Technical Bulletin

Bulletin Number: 376 Revision Number: R-02

SUBJECT: PLASTIC DRAIN TUBE FOR CONDENSATE

MODELS: All Dixie-Narco Can/Bottle Venders

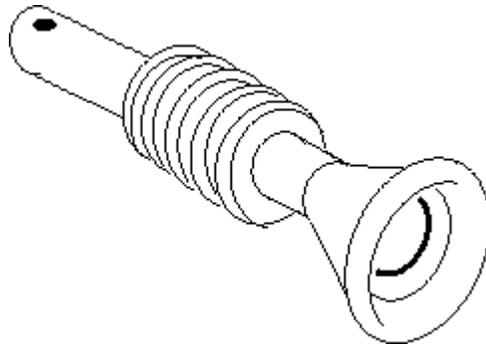
1. To start using the plastic drain tube in production venders to provide a more durable part.
2. To facilitate replacement of a broken or bent copper drain tube in the field.

1. Remove damaged or existing drain tube.
2. Insert the plastic drain tube (from the top) in the location from which copper tube was removed.
3. Push downward until the threaded area of drain tube makes contact.
4. Put silastic sealer beneath the flange of the drain tube (enough to seal).
5. Turn the tube clockwise, thread it downward until the flange of the drain tube seals against the tank. Secure with nut.
6. Reinstall the flexible drain hose on the drain tube.
